### Addendum No. 1

#### Cobbs Creek Playground (700 Cobbs Creek Parkway)

#### Philadelphia Redevelopment Authority

Issue Date: August 18, 2022

**TREE  
PROTECTION AND  
DEMO PLAN**

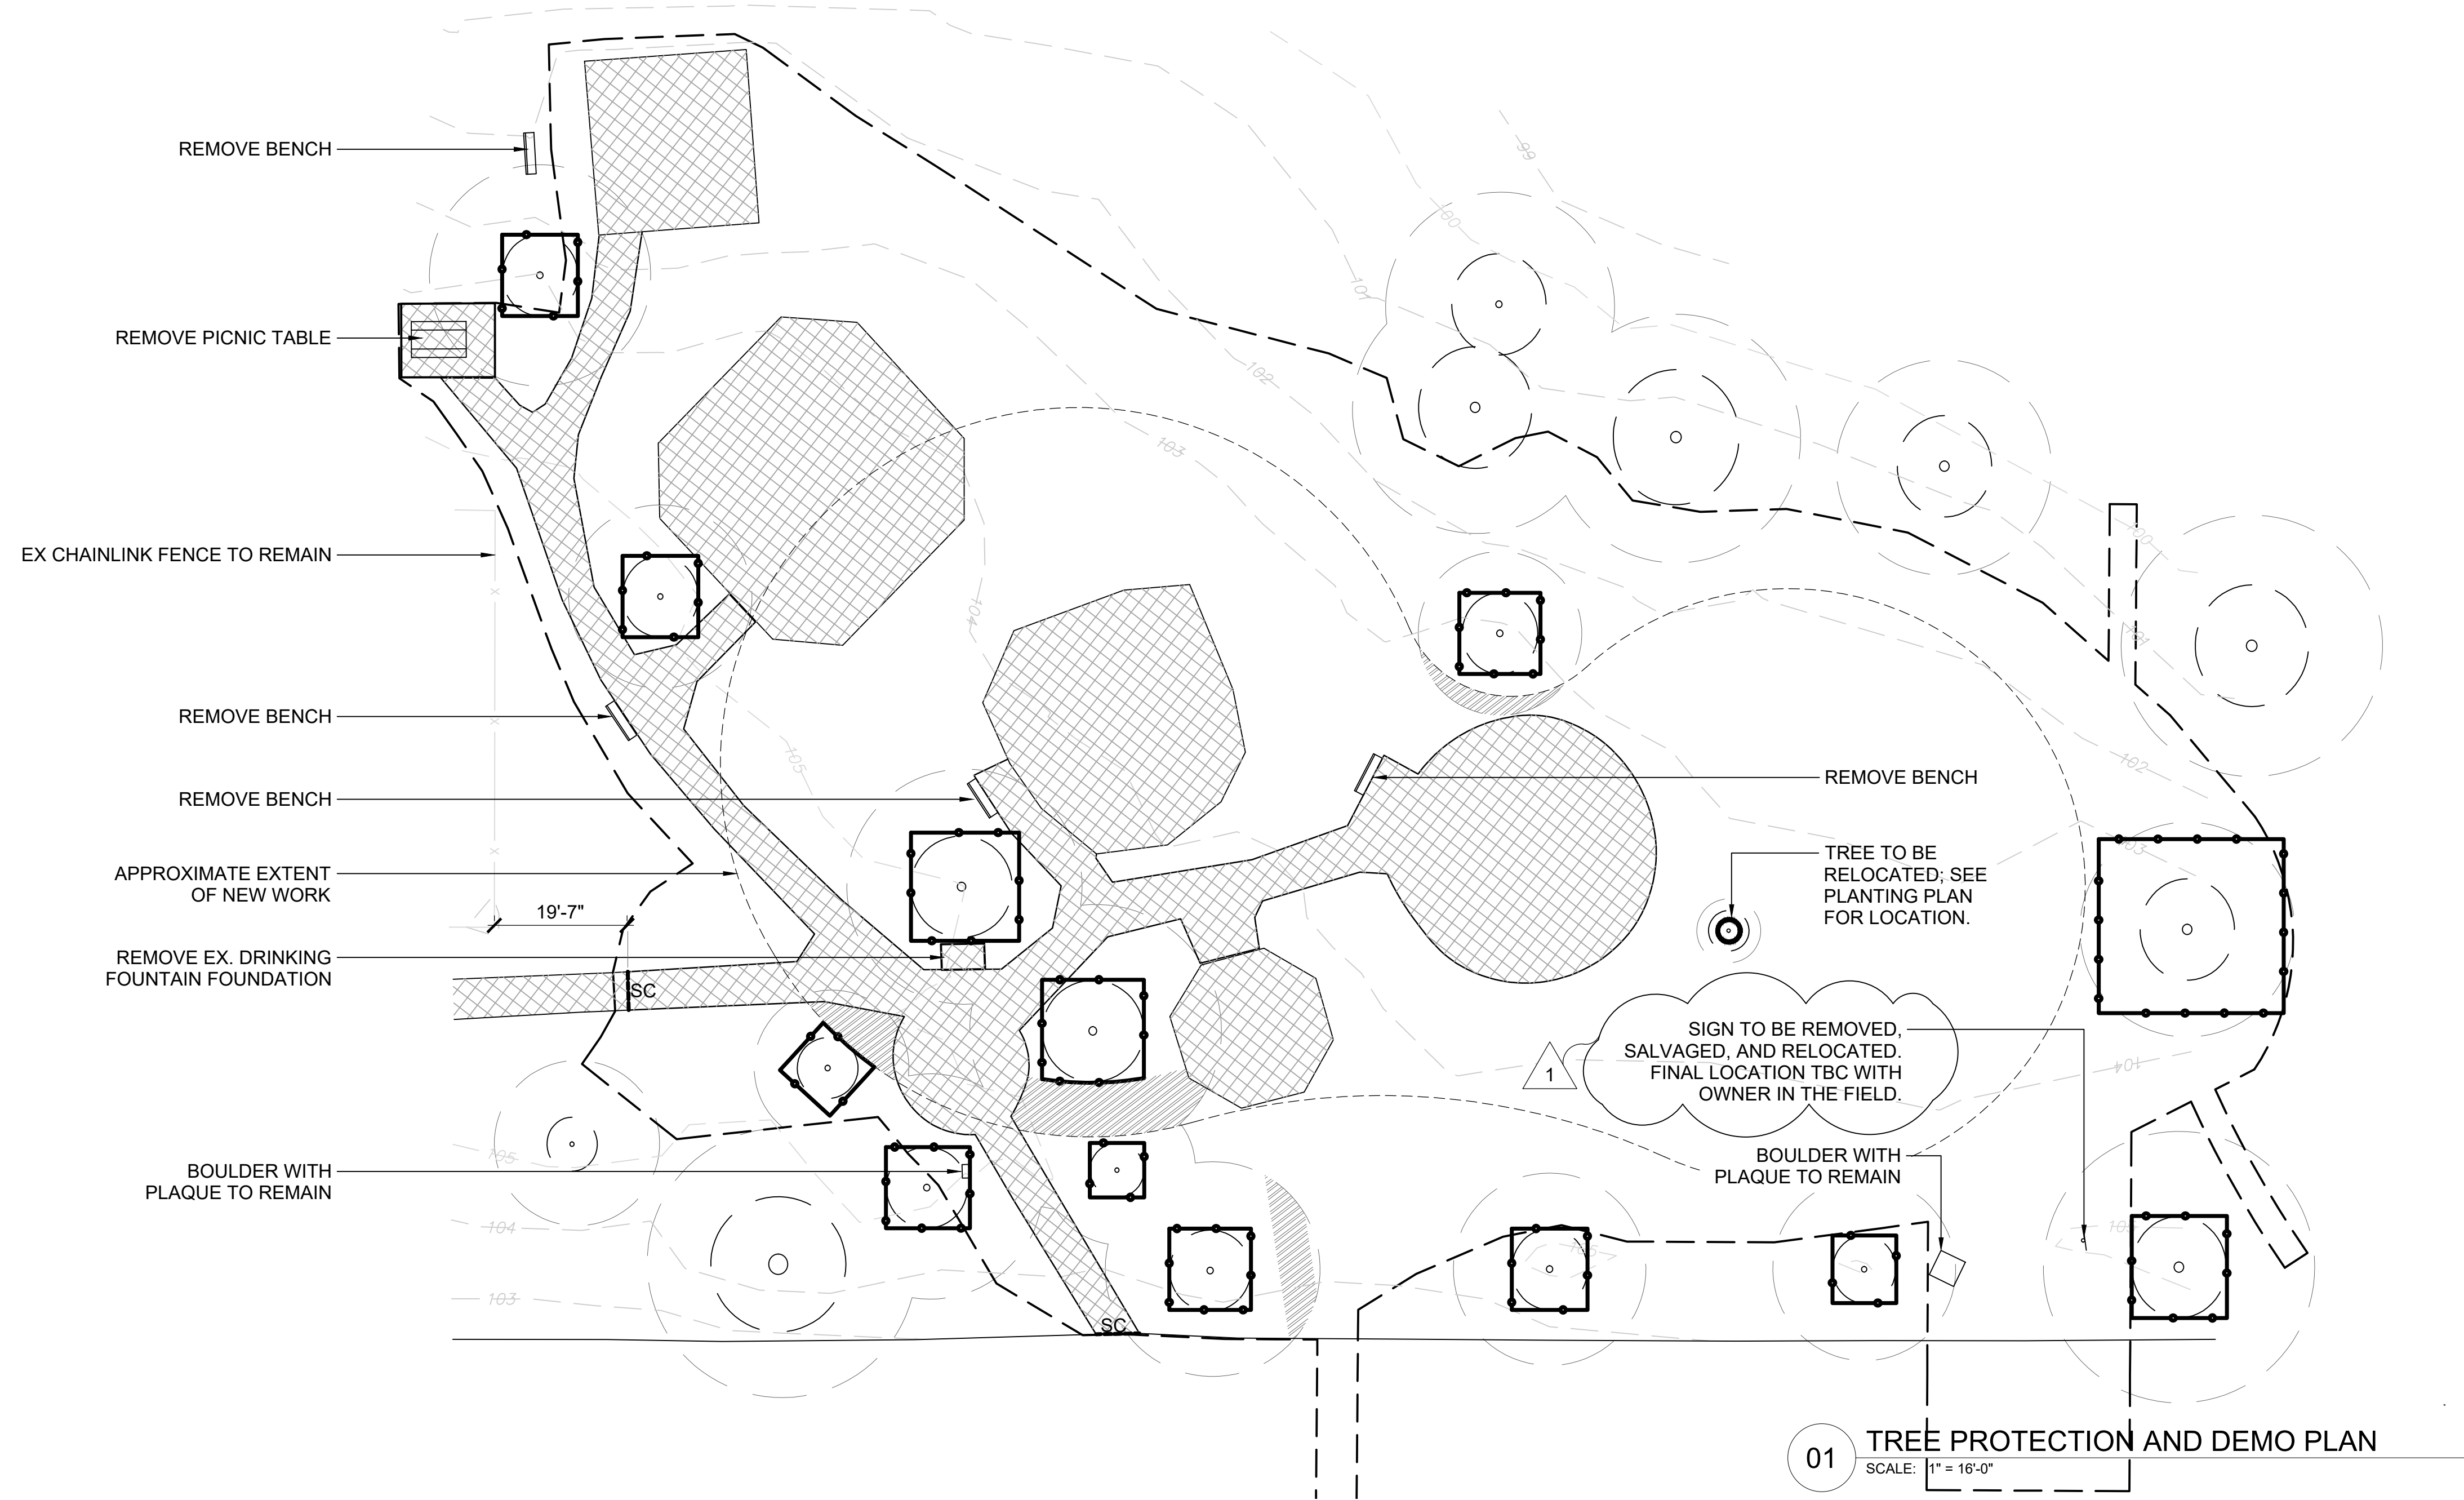
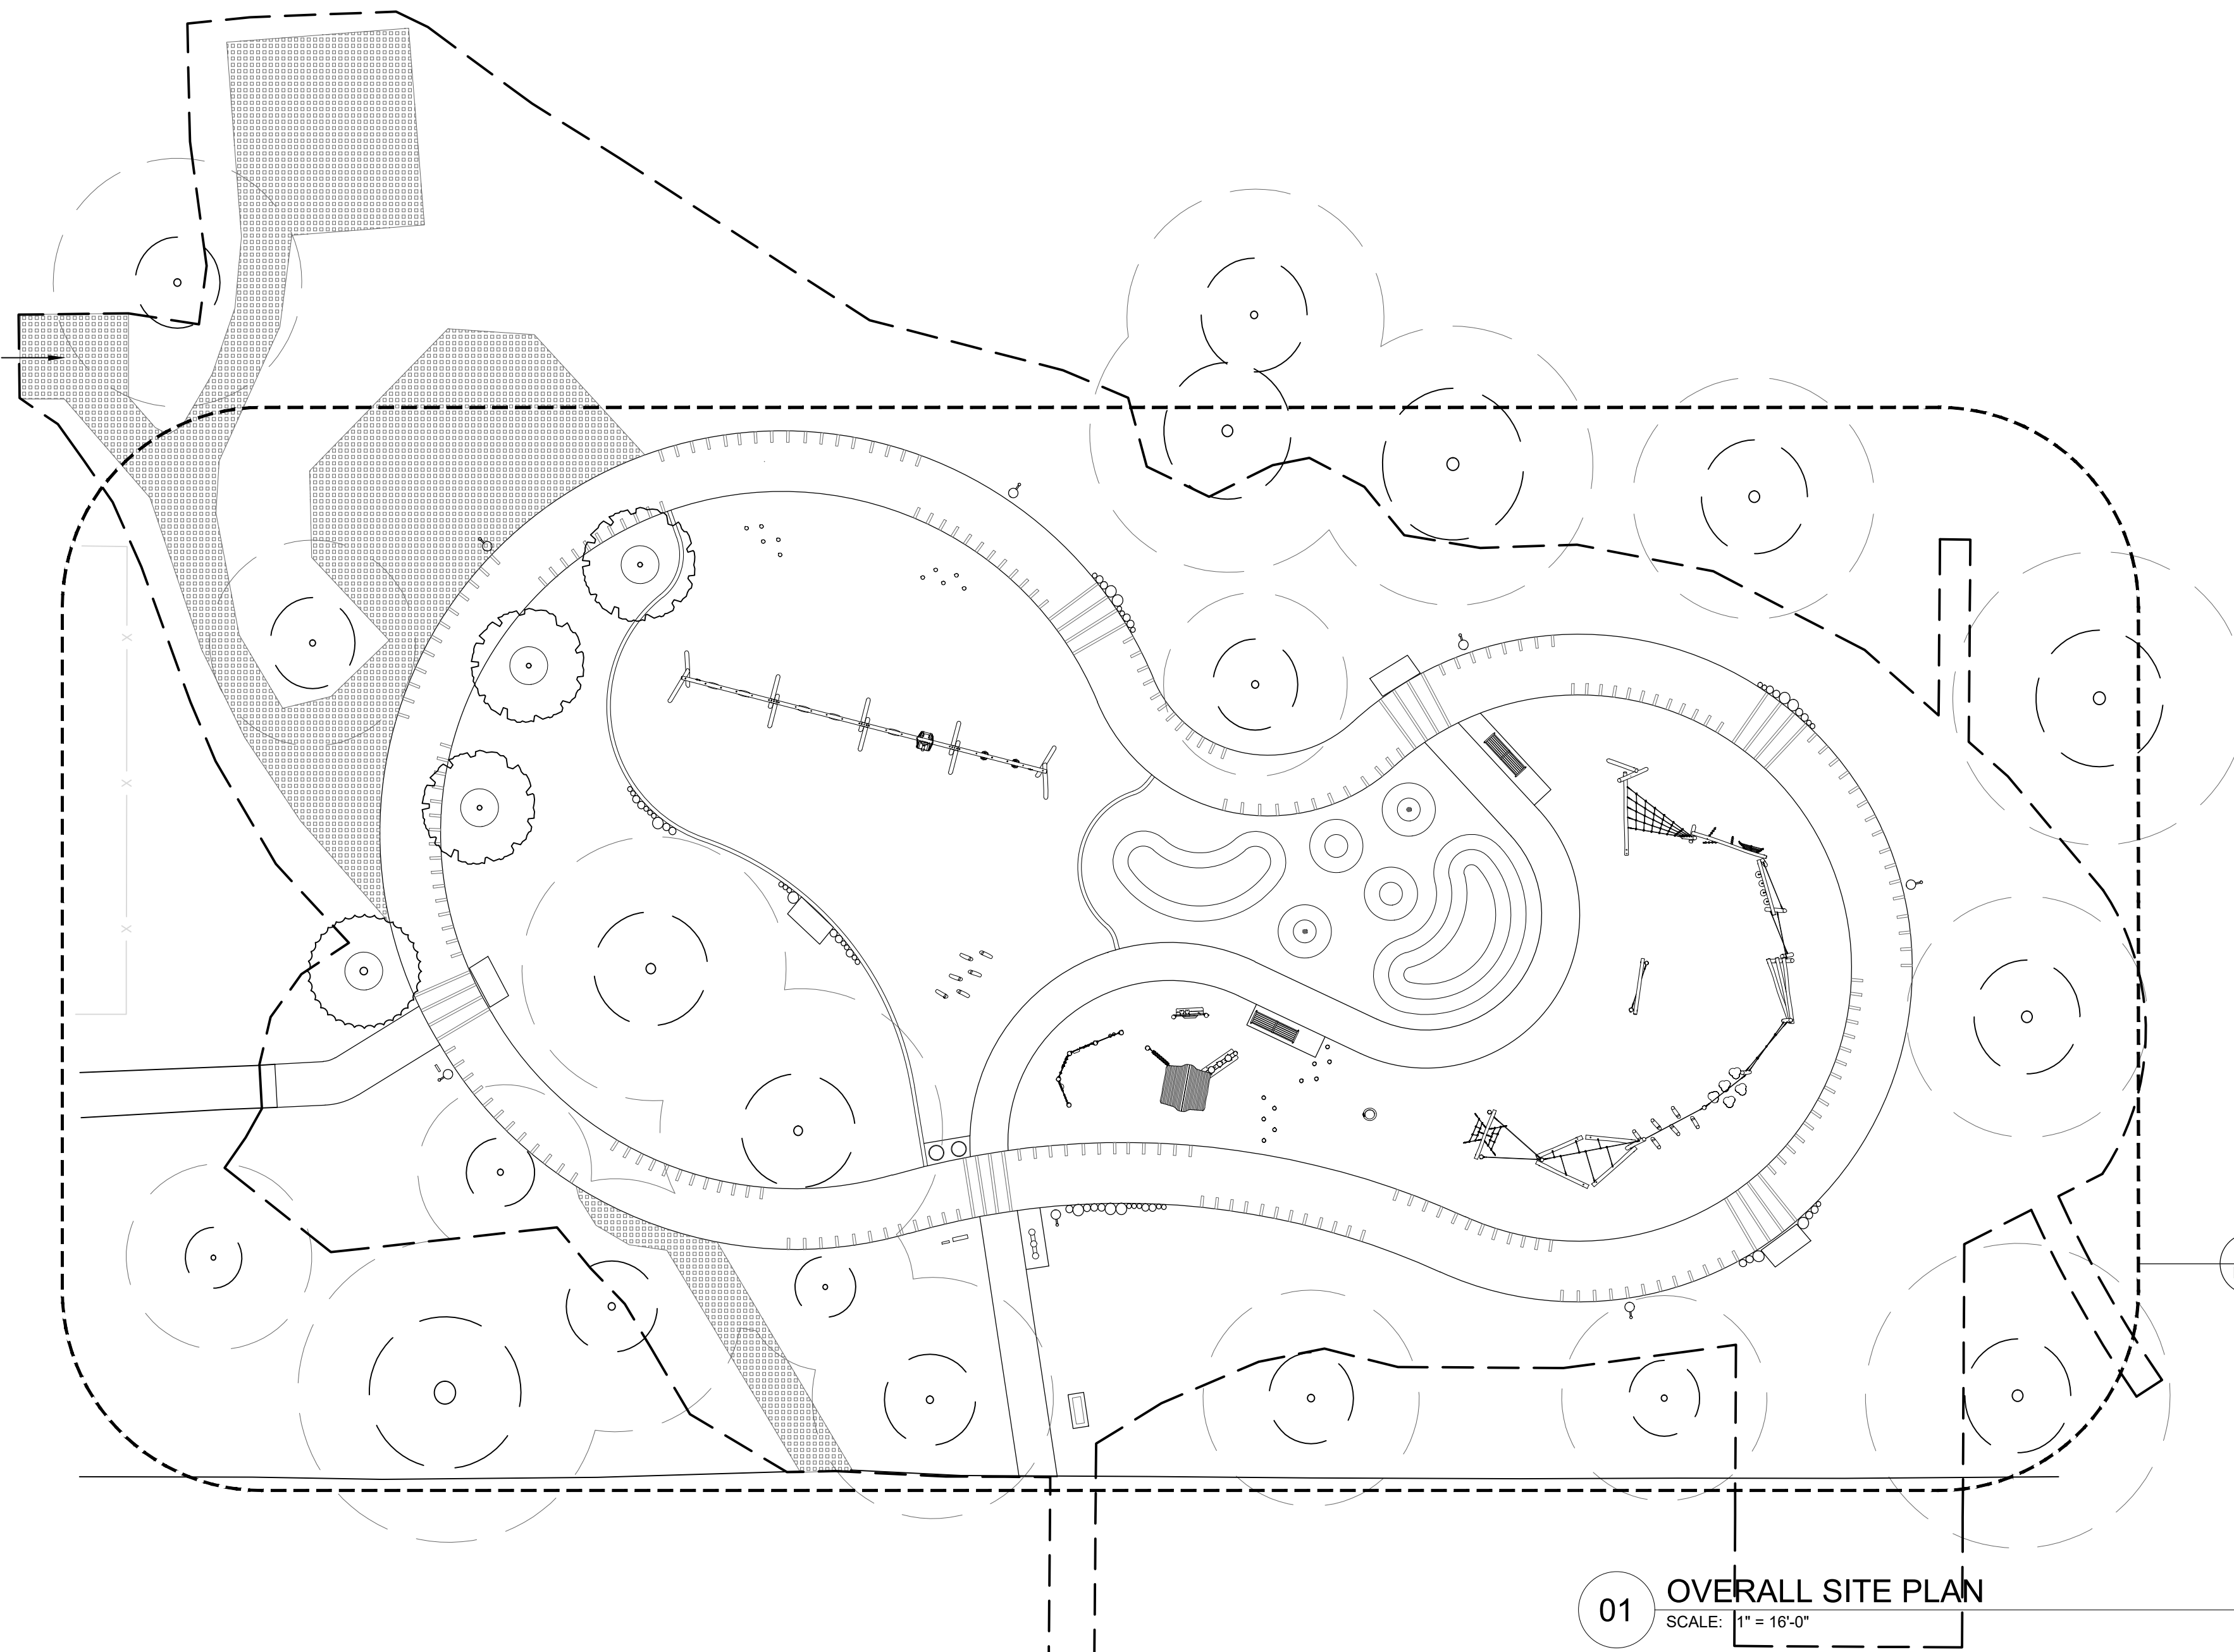
- a. L-100 – Tree Protection and Demo Plan
    - i. Added limit of work line.
    - ii. Added note to remove, salvage and relocate existing sign for construction entrance.

DRAWING NO:  
**L-101**  
SHEET 04 OF 22

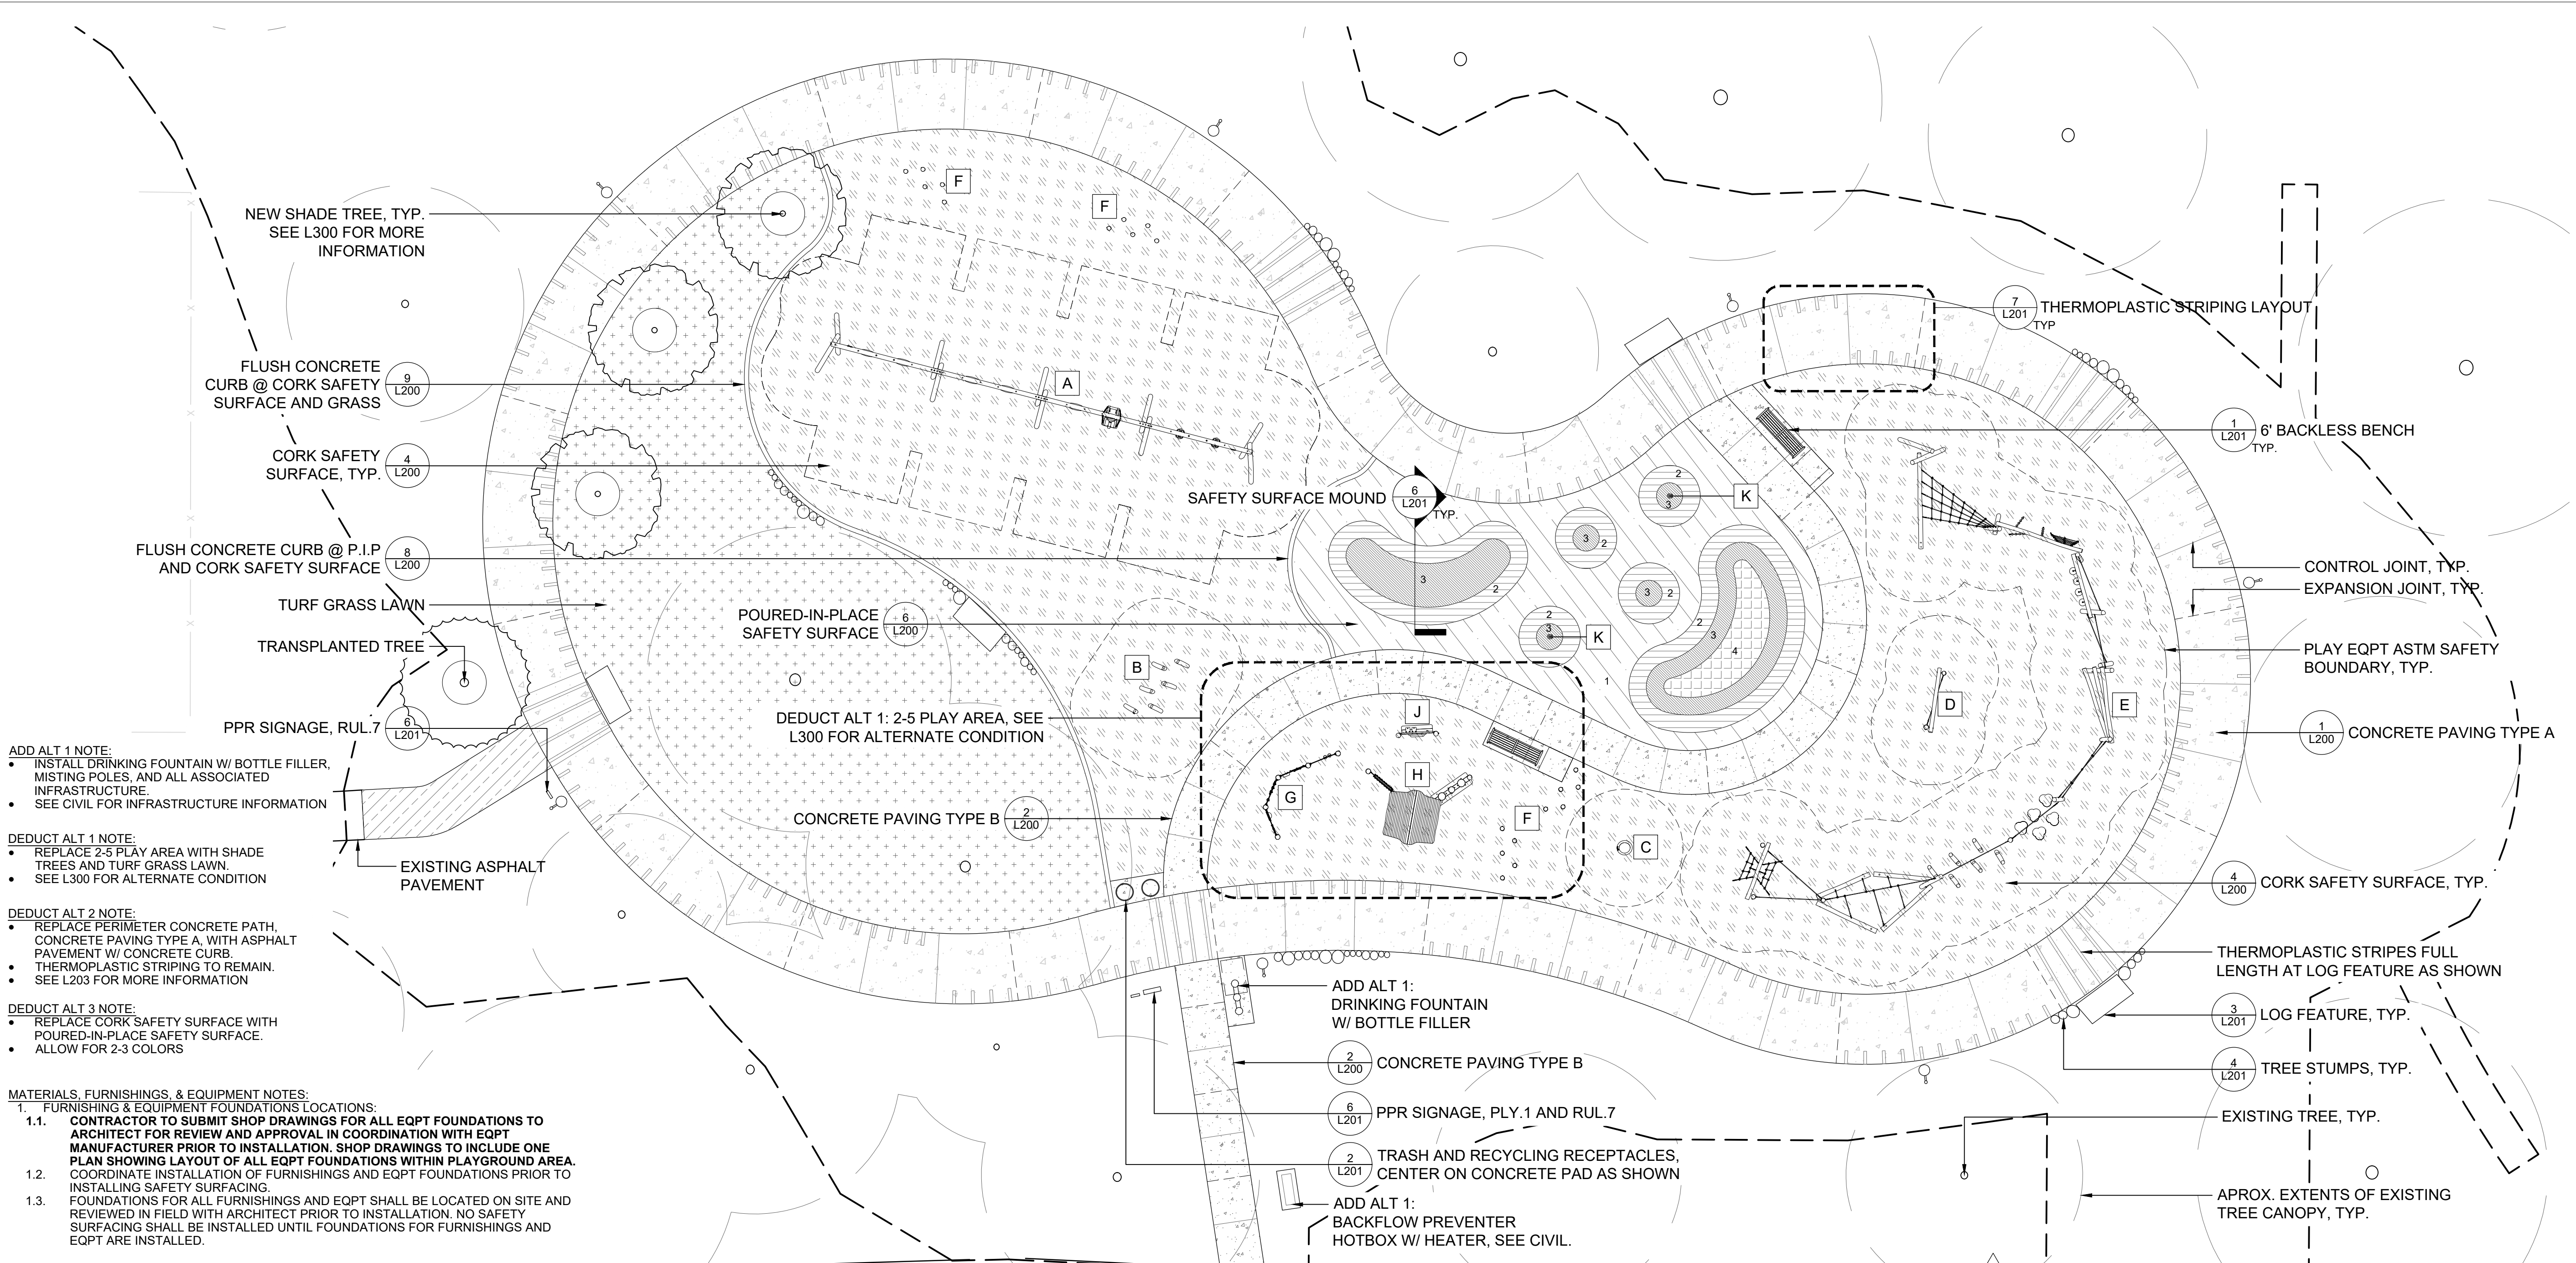
- b. L-101 Overall Site Plan
    - i. Added site plan note 6.
  - c. L-102 Materials, Furnishings & Equipment Plan
    - i. Added limit of work plan.
  - d. L-103 Layout Plan
